July 22nd, 2024
Bulletin#: TB2024-04

Technical Bulletin regarding Gas Valve Screw update

Models: All Gas Products Models

GAS VALVE KIT

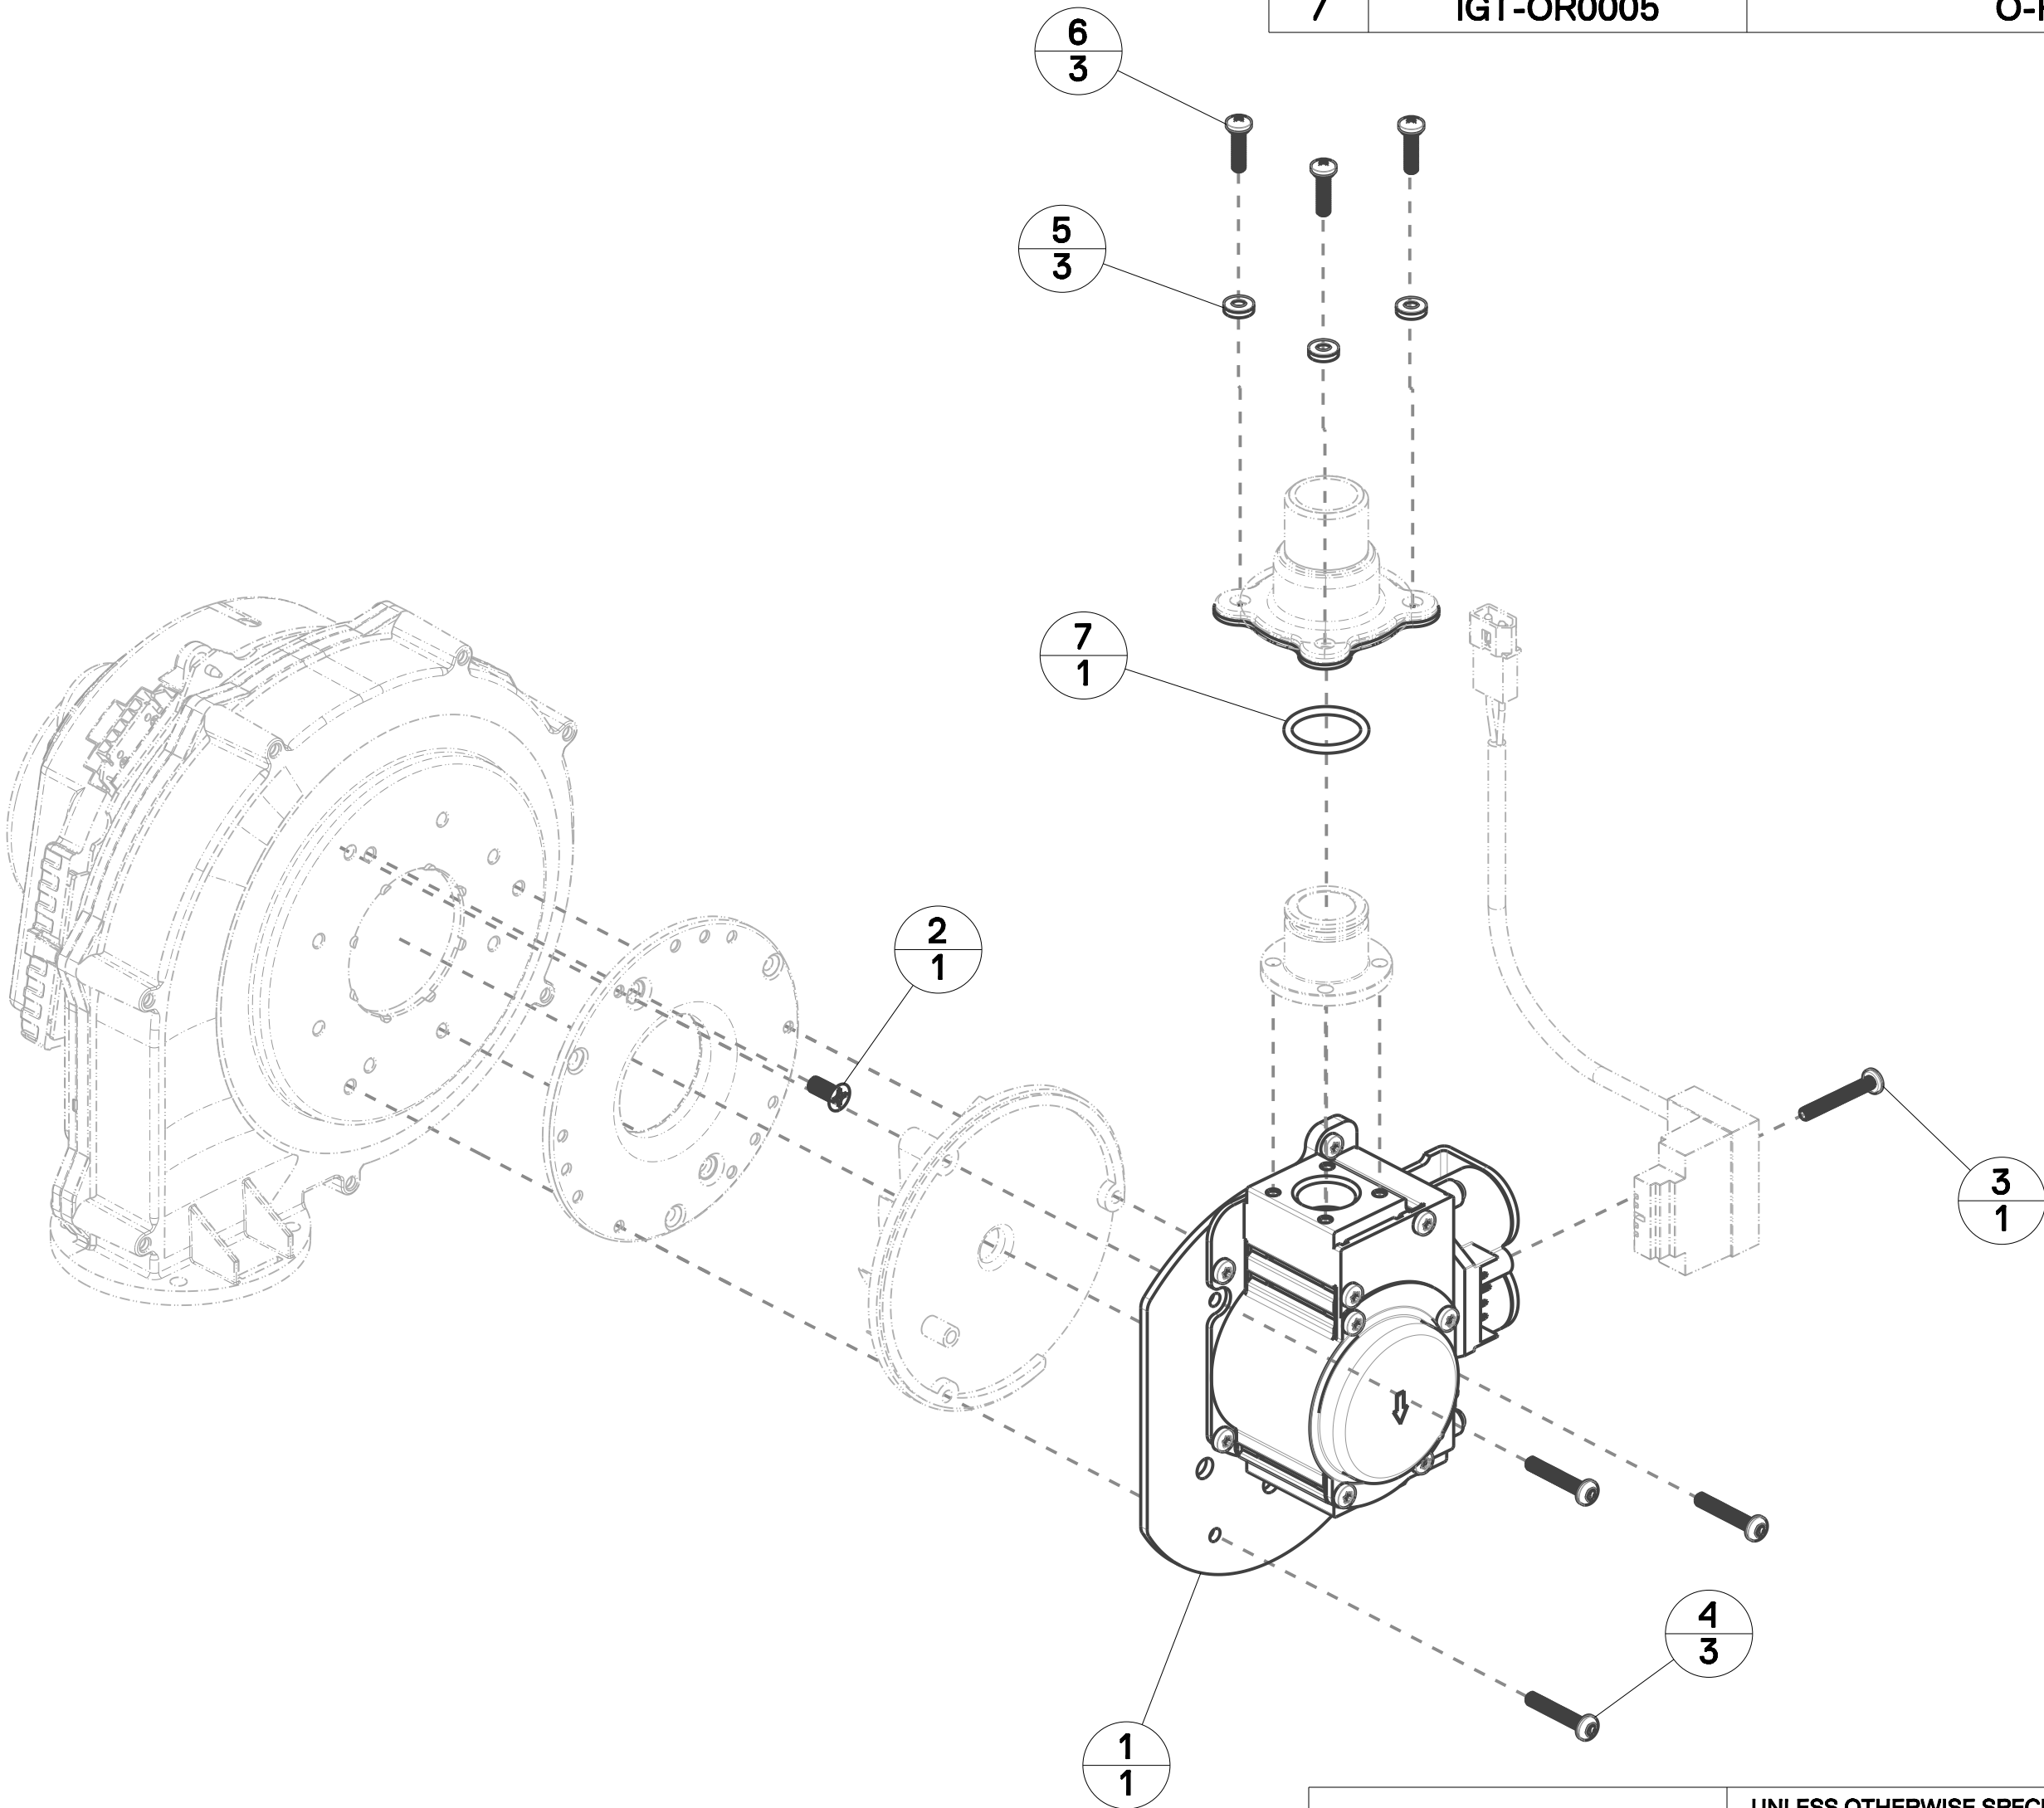
We are switching the IGT-HRD0038 (SCREW, PAN HD, TRIANGULAR-SHANK, TORX T20) used with the Gas valve to Blower mounting to a new supplier. The new part number is IGT-HRD0288 (SCREW, PAN HD, TRIANGULAR-SHANK, TORX T20). The new part is identical replacement.

Please discard the previously installed HRD0038 (3 places as shown below). Please use the newly supplied IGT-HRD0288 screws.

Failure to perform the above change could cause gas leaks. A gas leak check is always required when a gas valve or blower is replaced.
